DESCRIPTION	SHT. NO.
GENERAL LAYOUT	93
GENERAL NOTES	94-95
42" WATER MAIN PLAN AND PROFILE	96-100
24" WATER CONNECTION PLAN AND PROFILE	101
12" WATER CONNECTION PLAN AND PROFILE	102-103
CORROSION PROTECTION	104-109
WATER DETAILS	110-113

STATE OF HAWAII DEPARTMENT OF TRANSPORTATION HIGHWAYS DIVISION	
GENERAL LAYOUT	
KAHEKILI HIGHWAY WIDENING Likeli Hwy. to Vicinity of Haiku Road F.A. PROJECT NO. NH-083-1(26)	
SCALE: AS NOTED	DATE: APRIL 1994
SHEET No. WT1 OF WT21 SHEETS

STATE OF HAWAII DEPARTMENT OF TRANSPORTATION HIGHWAYS DIVISION	
GENERAL WATER NOTES	
KAHEKILI HIGHWAY WIDENING Likelike Hwy. to Vicinity of Haiku Road F.A. PROJECT NO. NH-083-1(26)	
SCALE: AS NOTED	DATE: APRIL 1994
SHEET No. WT2 OF WT21 SHEETS

PLAN AND PROFILE
42" WATER MAIN
W.L. STA. (-)1+85.97 TO 9+50

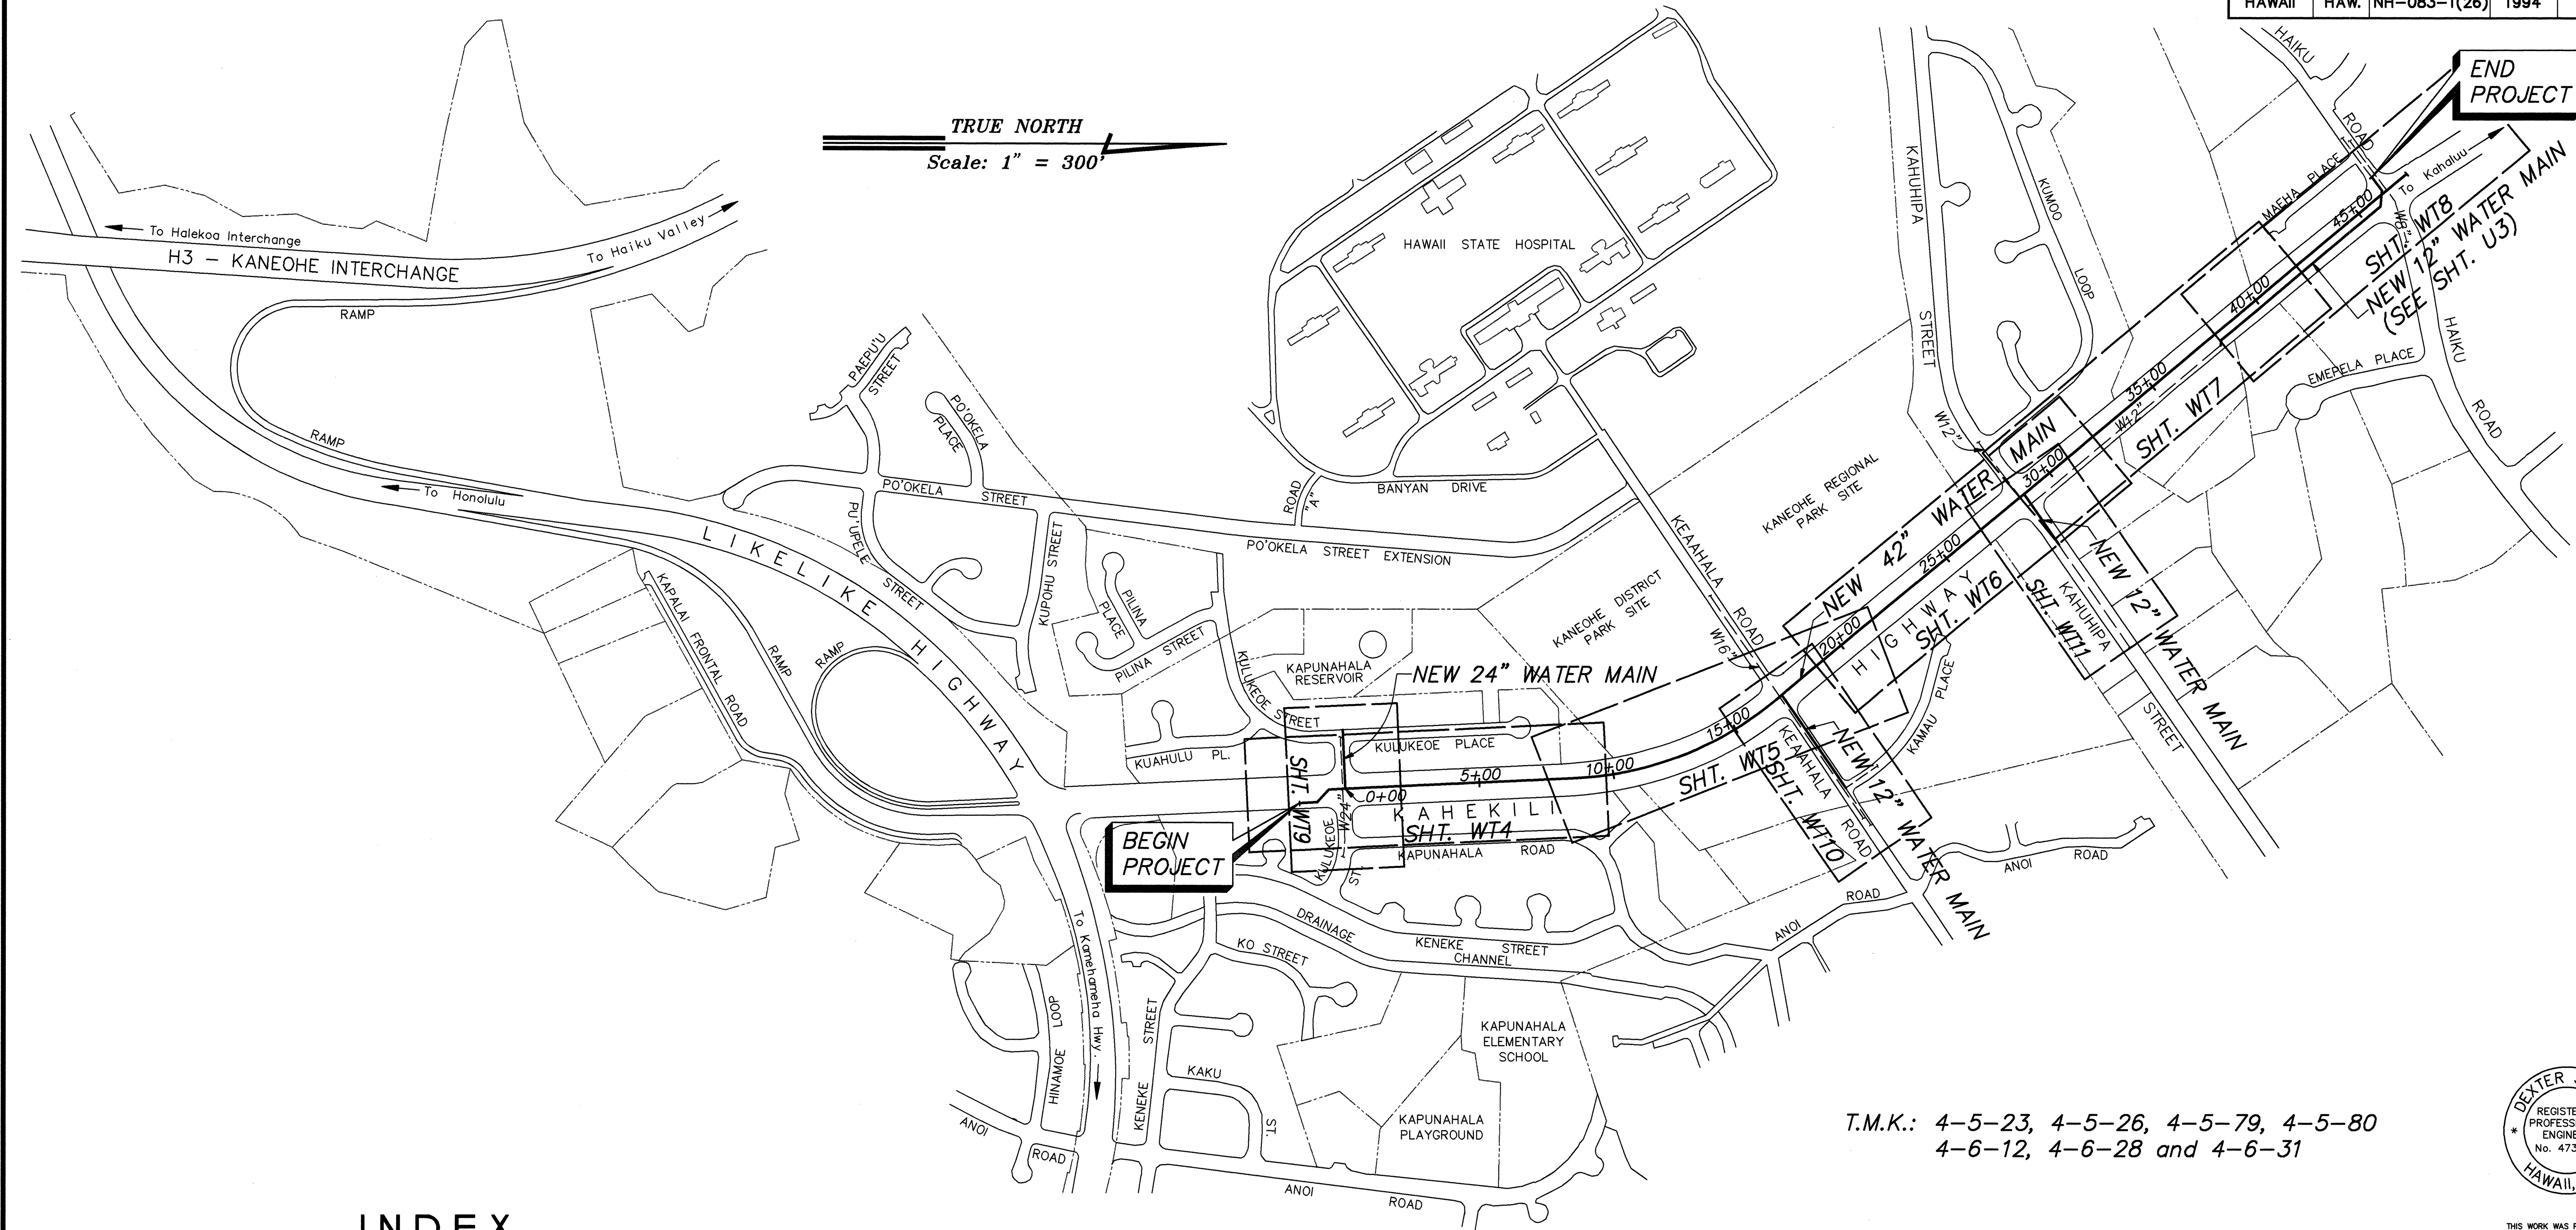
DELETED DEPARTMENT OF TRANSPORTATION
SERVICES SIGNATURE BLOCK.
ADDED DWM SIGNATURE BLOCK AND
TAX MAP KEY.

**PLAN AND PROFILE
KULUKEOE STREET**

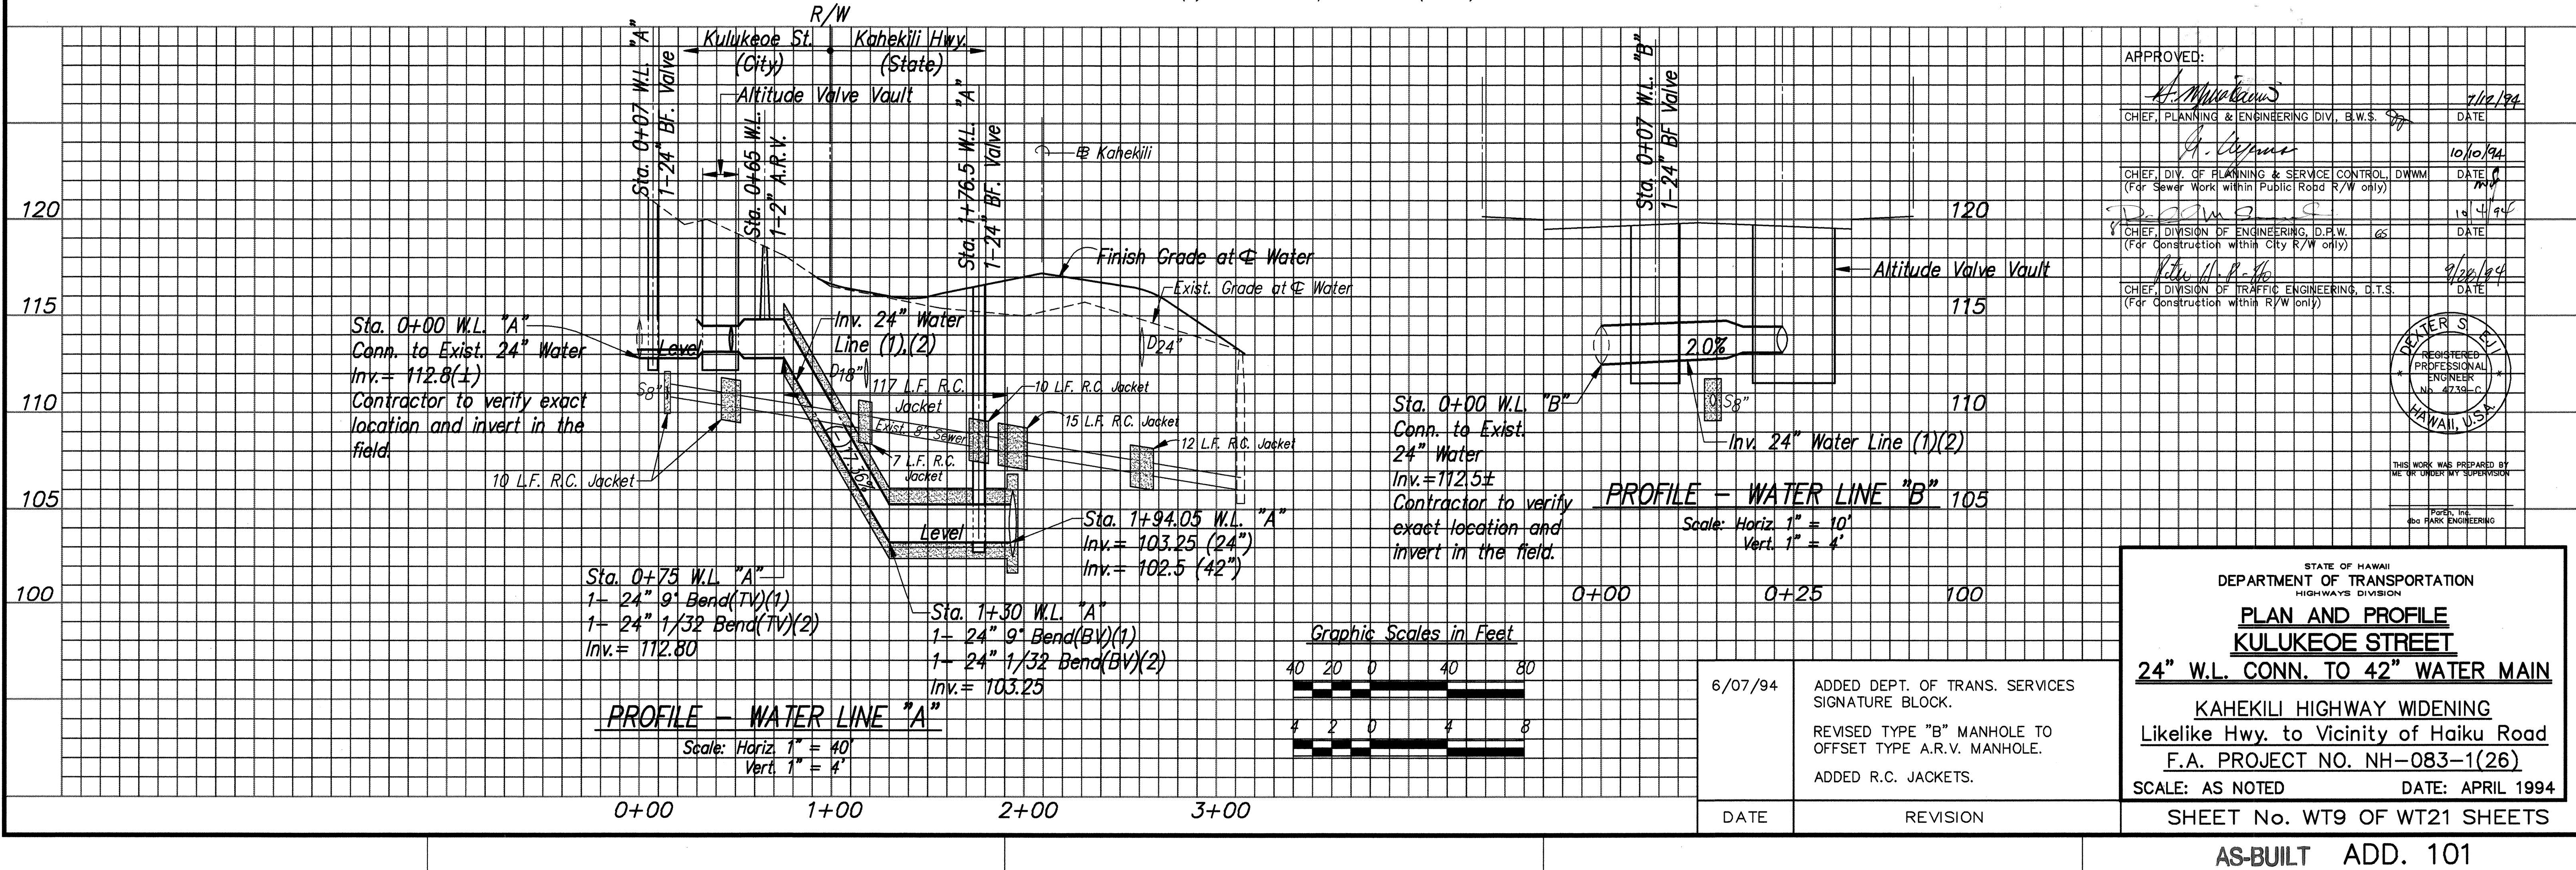
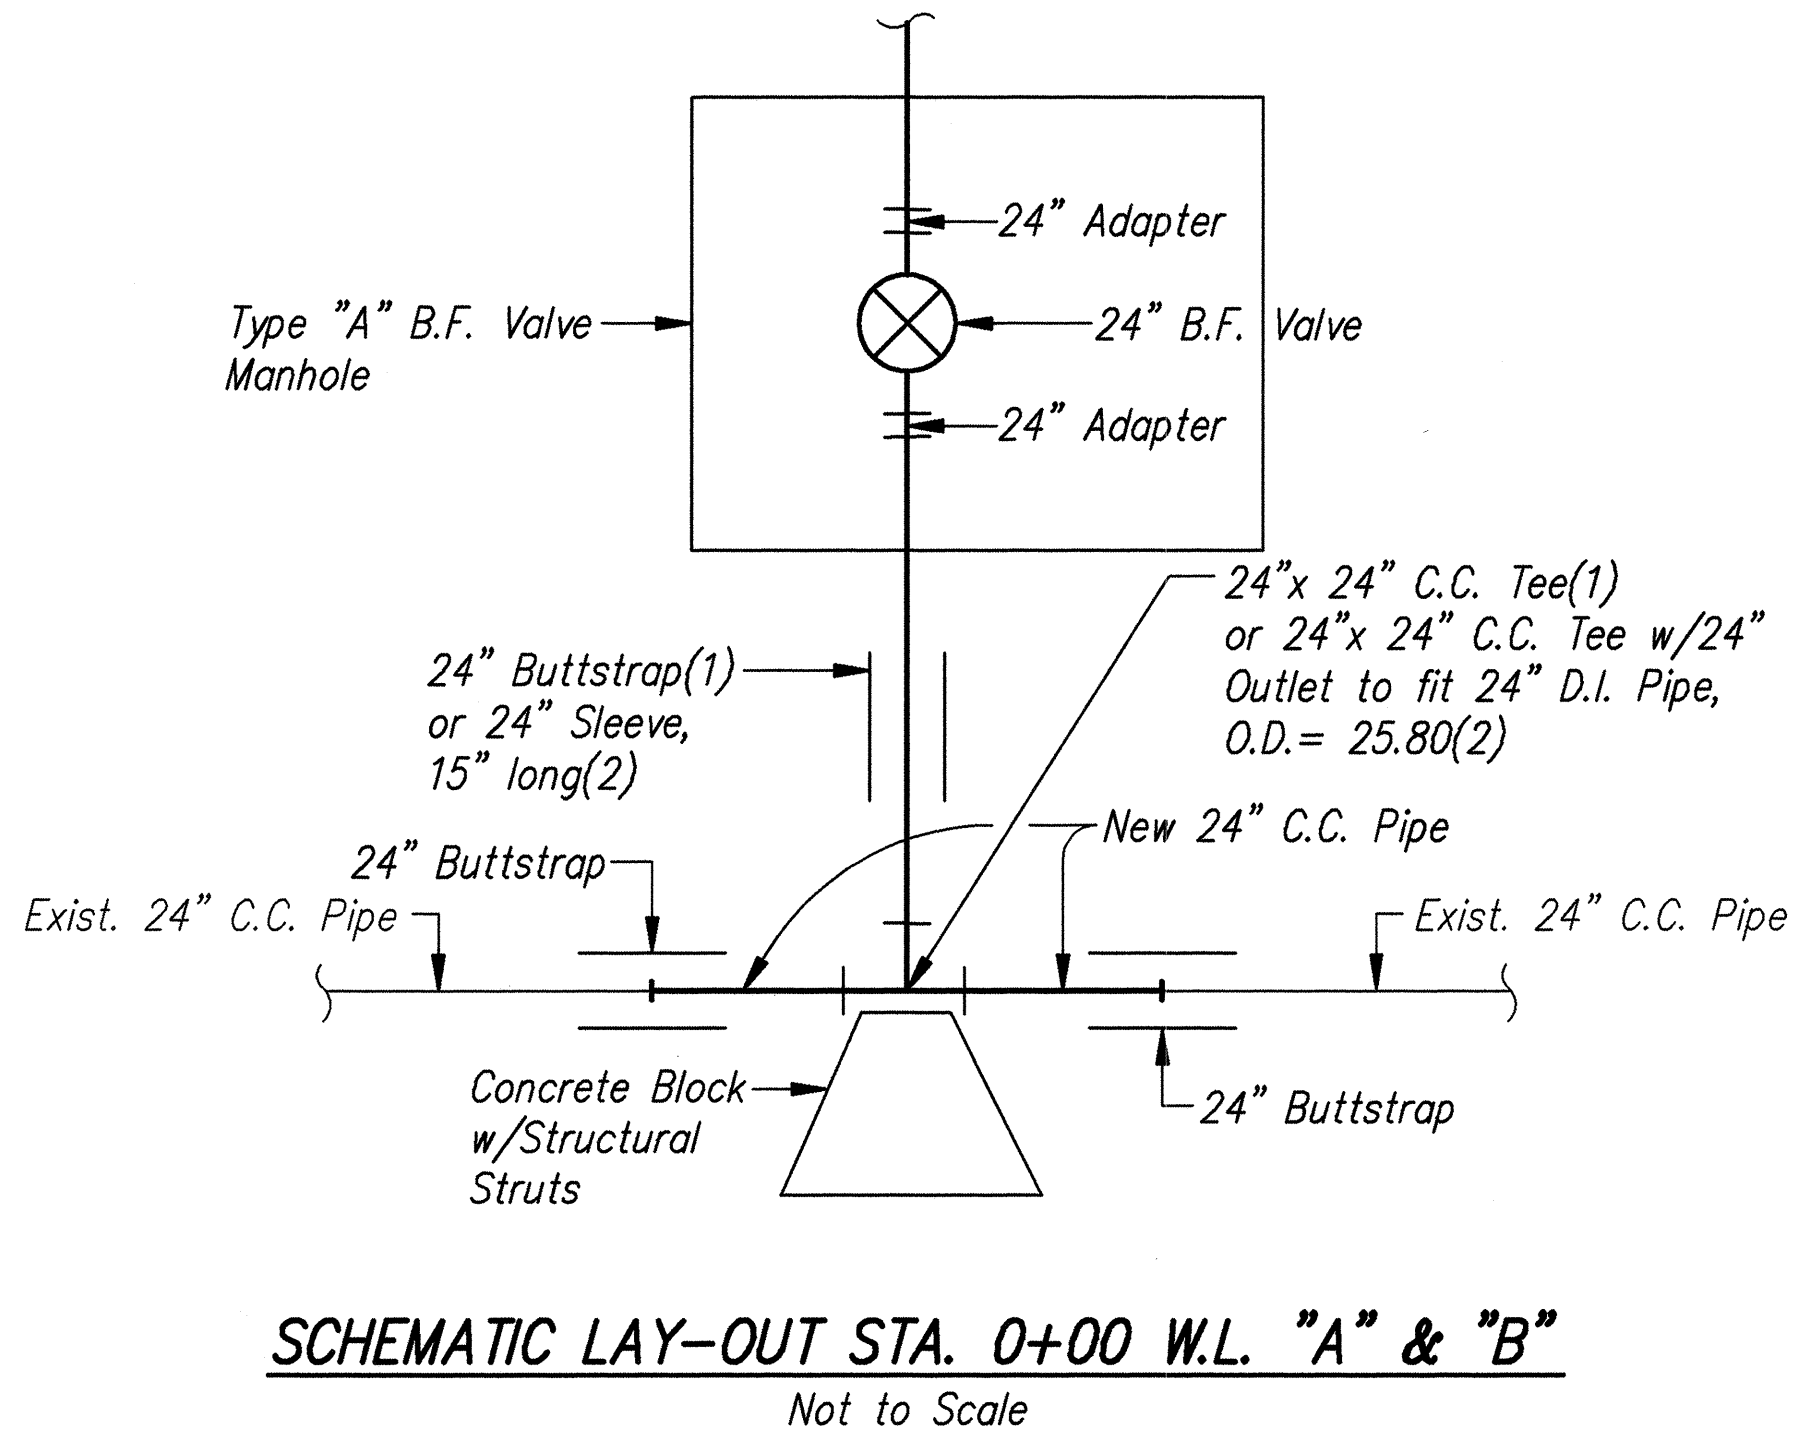
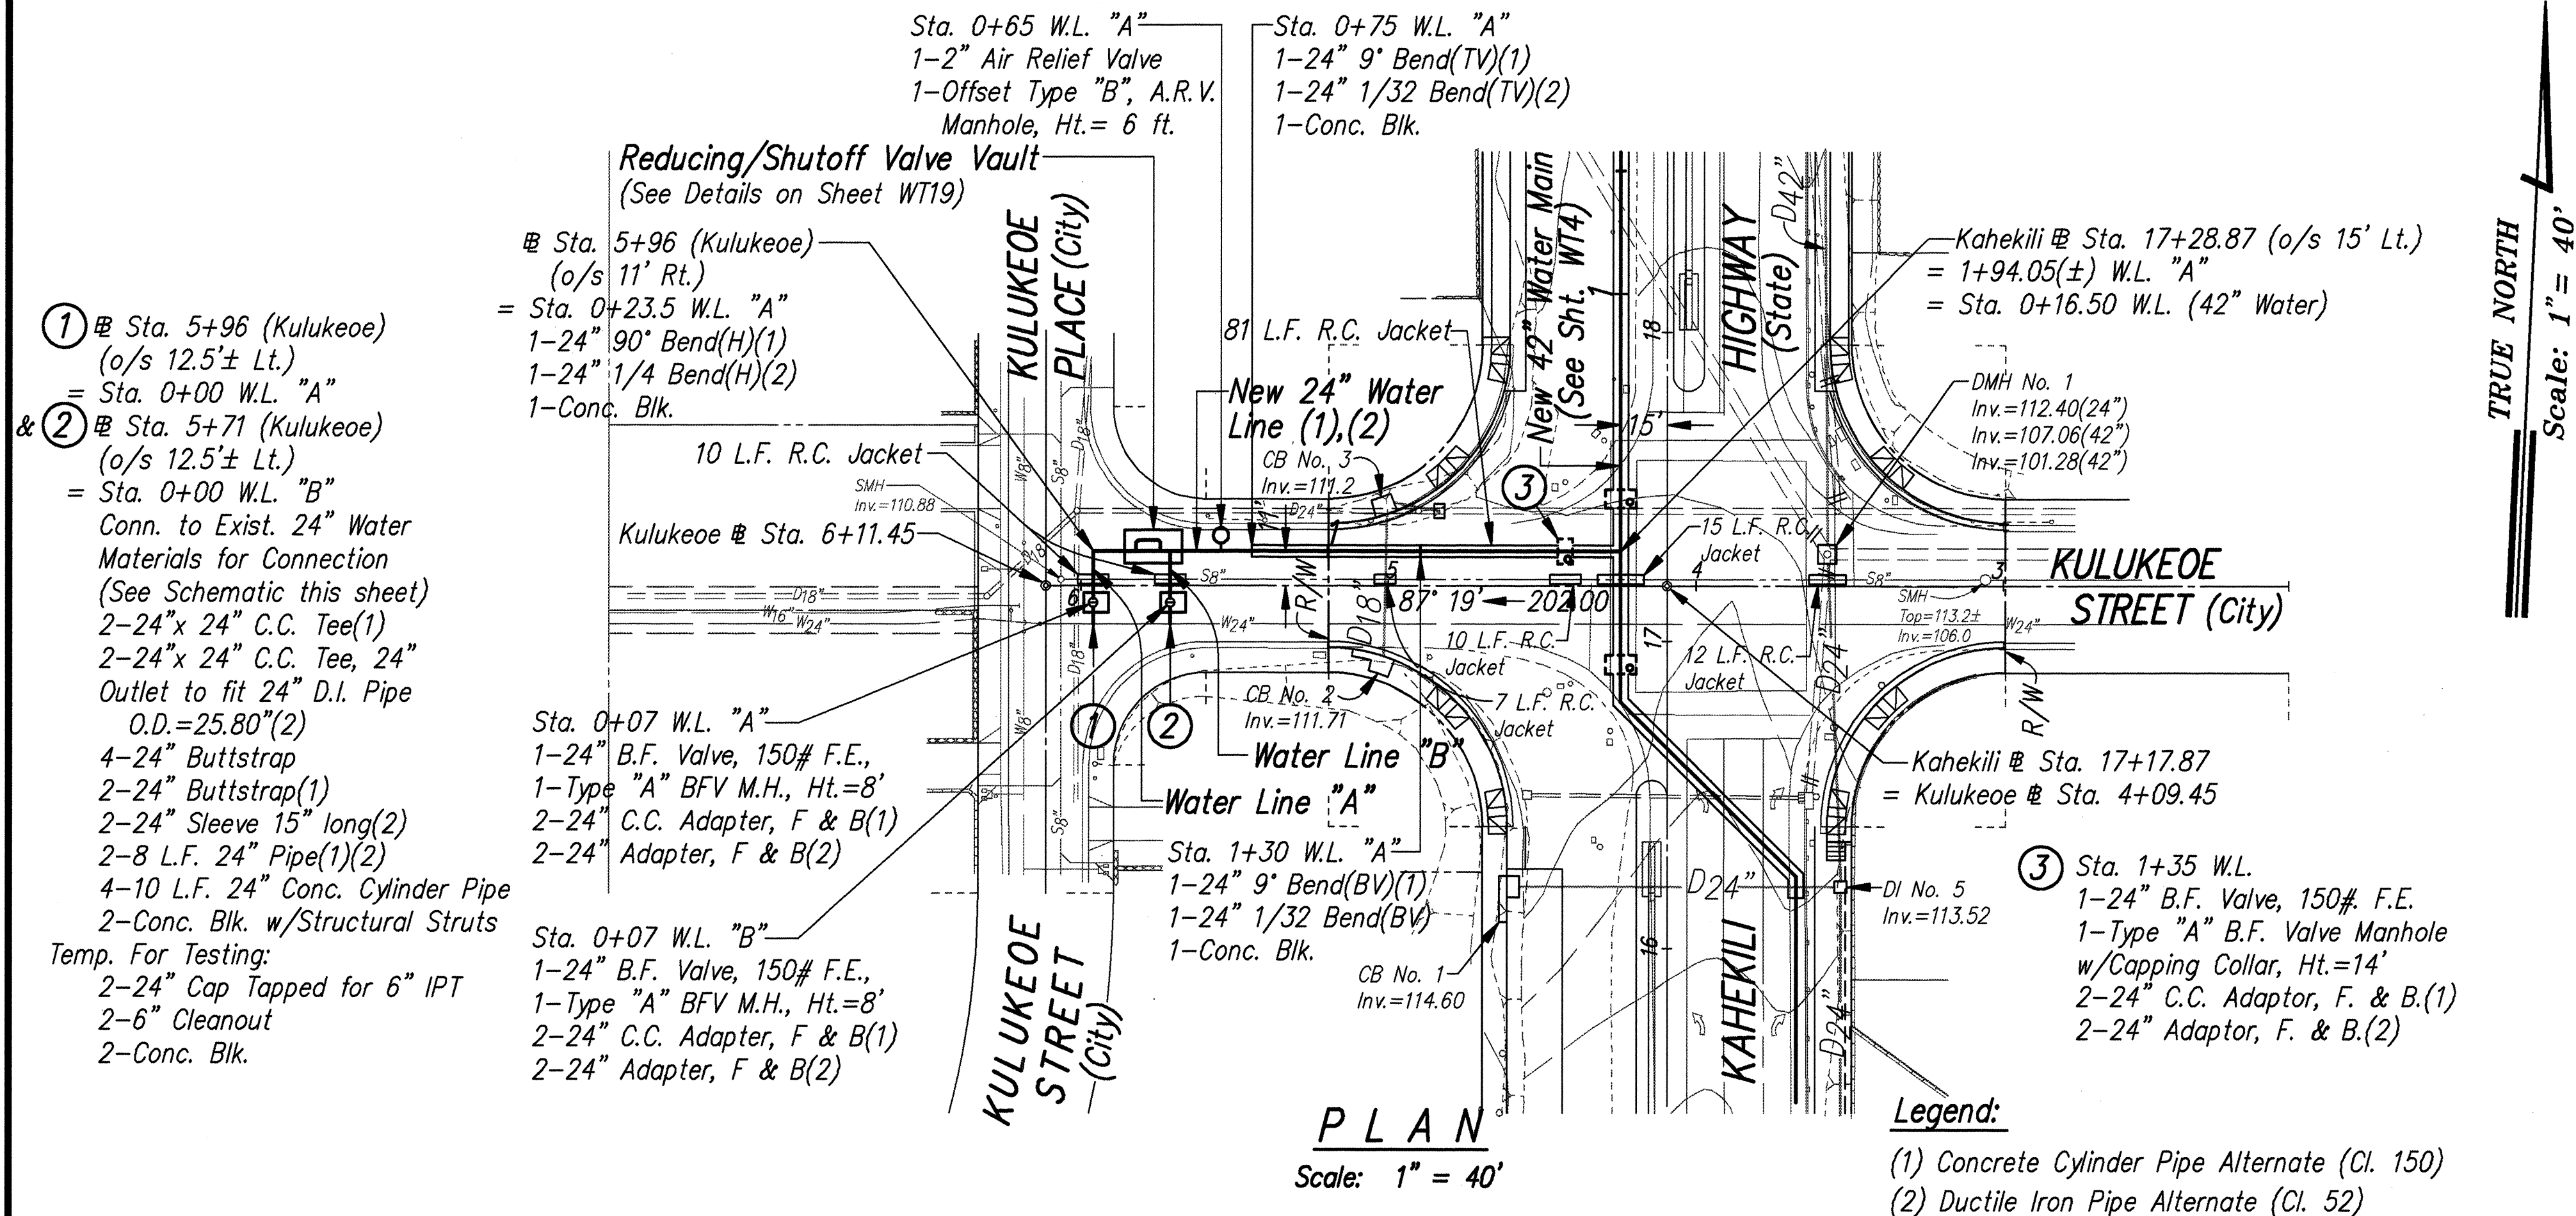
6/07/94	ADDED DEPT. OF TRANS. SERVICES SIGNATURE BLOCK.
	REVISED TYPE "B" MANHOLE TO OFFSET TYPE A.R.V. MANHOLE.
	ADDED R.C. JACKETS.
DATE	REVISION
